FARR WEST CITY COUNCIL AGENDA

RE: **FARR WEST BUSINESS PARK SUBDIVISION & SITE PLAN**
Final Plat and Site Plan Review

FARR WEST BUSINESS PARK
A 4 LOT COMMERCIAL SUBDIVISION
PRELIMINARY PLAT

**Grading
Plan**

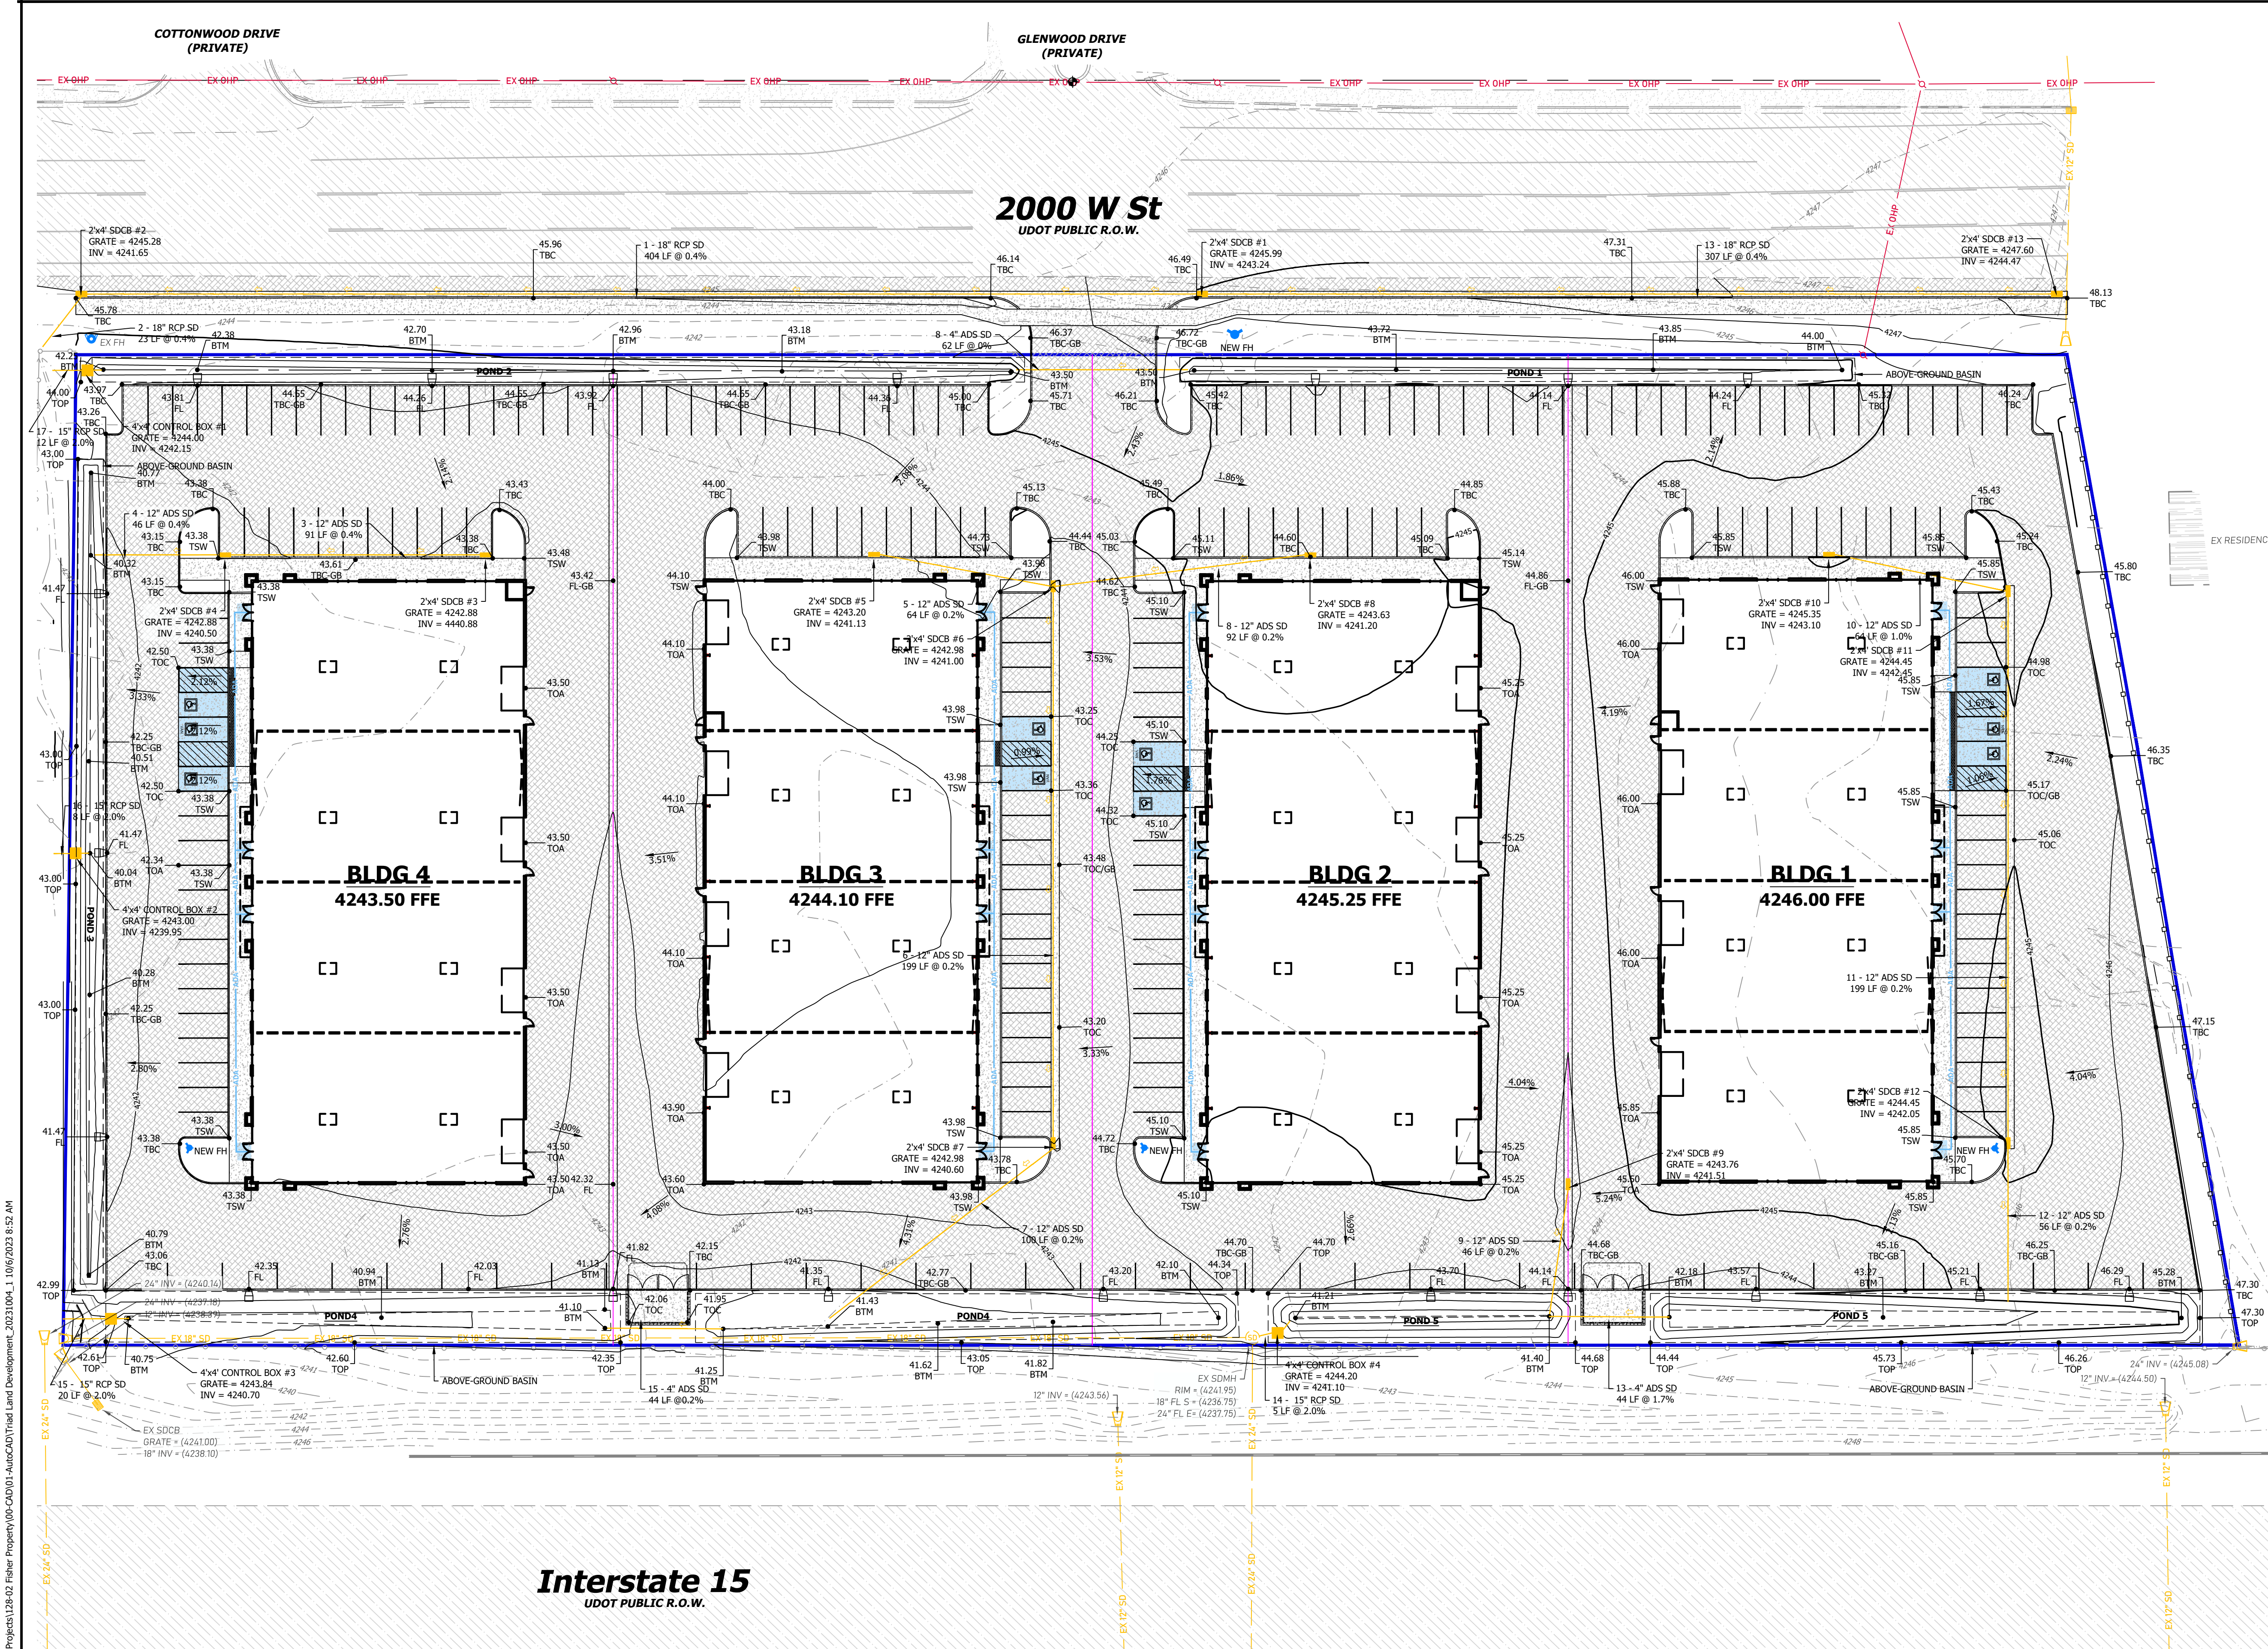
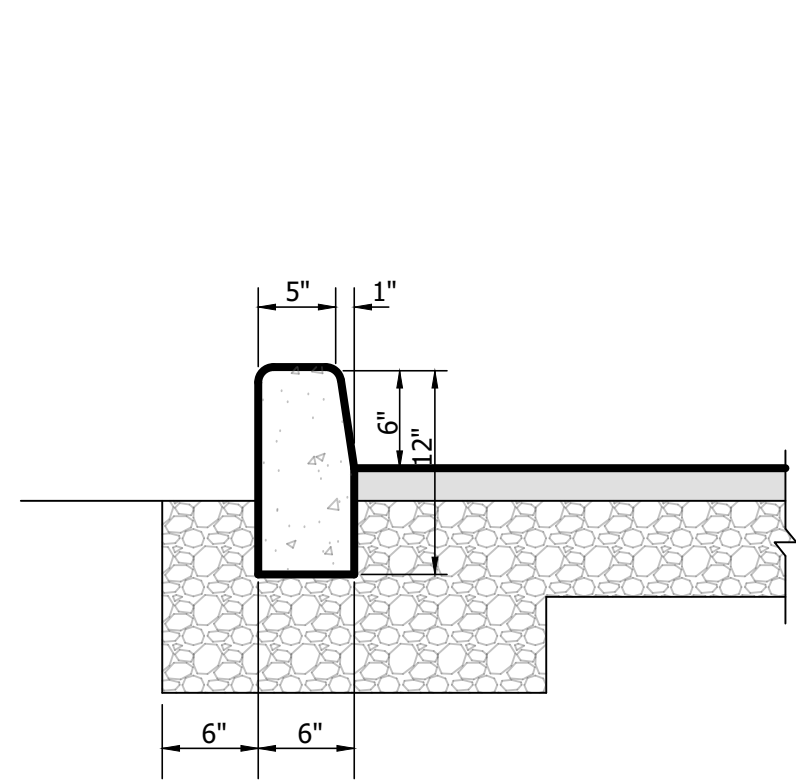
One item to note on this site is that the calculated landscaped area (12.5%) includes the detention basins. Without the detention basins included, the landscaped area is about 7% which is less than the 10% requirement. The new commercial landscaping ordinance states that detention basins are not allowed in the landscape area calculation. This ordinance was adopted on July 6th of this year and is listed in the municipal code online as pending codification. The plans for this development were submitted in August but they were unaware of this change. The proposed detention basin areas are narrow, shallow basins around the perimeter of the site and have some shrubs and plants planned along the top of the basins. We would recommend allowing the landscape plan to remain as-is due to the close timing of the code change, and since these detention areas have plant materials and blend in well with the overall site landscaping.
